City and Borough of Wrangell Planning and Zoning Commission AGENDA

PLANNING AND ZONING COMMISSION Regular Meeting September 25, 2025 Staff Report

Subject: (PH) Preliminary Review of a Planned Unit Development Application and Subdivision for Lot D of the Torgramsen-Austin Subdivision according to Plat No. 2017-1, zoned Zimovia Highway Mixed Use, owned and requested by Southeast Alaska Regional Health Consortium.

O ARCHITECTURAL SITE PLAN

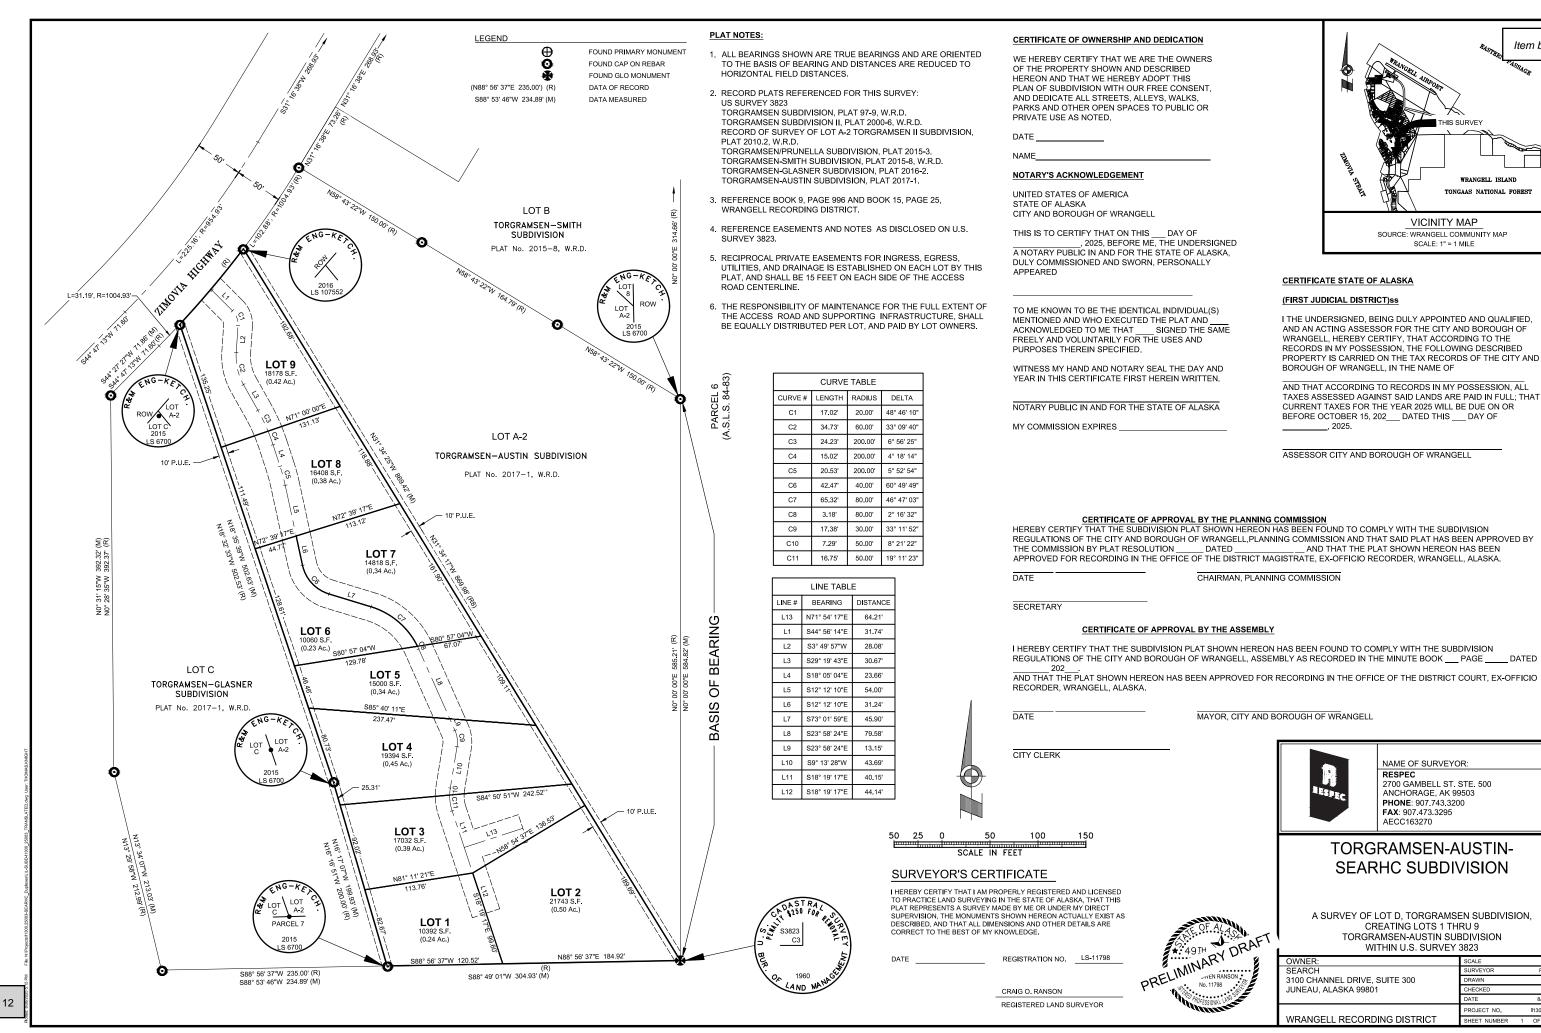
The development narrative identifies setbacks of 20 feet front, 15 feet sides, and 5 feet rear. However, the ZHMU district requires 20-foot front and rear setbacks and 15-foot side setbacks. Given the available site area and building placement, the full 20-foot rear setback appears achievable and should be applied to ensure compliance with district standards.

The proposed private access and utility easement is approximately 700 feet, exceeding the 400-foot maximum allowed under WMC 19.30.020(E).

The proposed subdivision creates 9 lots, whereas the maximum allowed under flag lot standards with Borough utilities is 4 lots (WMC 19.30.020(G)).

While the primary access easement accommodates utilities, the utility plans show underground infrastructure crossing individual lots before entering the roadway. These utility easements must also be dedicated by the plat with adequate width to ensure future maintenance and access.

- Easement Dedication: All access and utility easements must be dedicated by plat with
 established metes and bounds descriptions, including underground utilities crossing lot 9
 before entering the primary roadway. All easements shall provide adequate width to
 ensure long-term maintenance.
- 2. Easement Agreements: Plat notes shall refer to a common access and utility easement agreement with terms and provisions for maintenance and responsibility. The Borough may accept one comprehensive subdivision agreement or separate agreements (e.g.,

- 3. State ROW Permit: Developer must obtain a State right-of-way permit to tie into municipal utilities within the Zimovia Highway right-of-way.
- 4. Service Valves: Service valves shall be installed at each unit/duplex to ensure water and sewer services can be terminated if necessary.

- 5. Stormwater Management: Provide stormwater management details including culverts and drainage conveyance as part of the final plat and construction documents.

- 6. Turnaround: Demonstrate adequate turnaround radius at the road terminus to accommodate emergency and service vehicles.
- Parking and Access: Parking shall comply with WMC standards, with at least one stall per dwelling unit and two per lot. Parking within the easement shoulders shall be prohibited to maintain clear access.

- 8. Fire Protection: Install fire hydrants along the access road as required by the Fire Department.
- Backflow and Metering: Install backflow preventers and water meters as required by Borough policy.
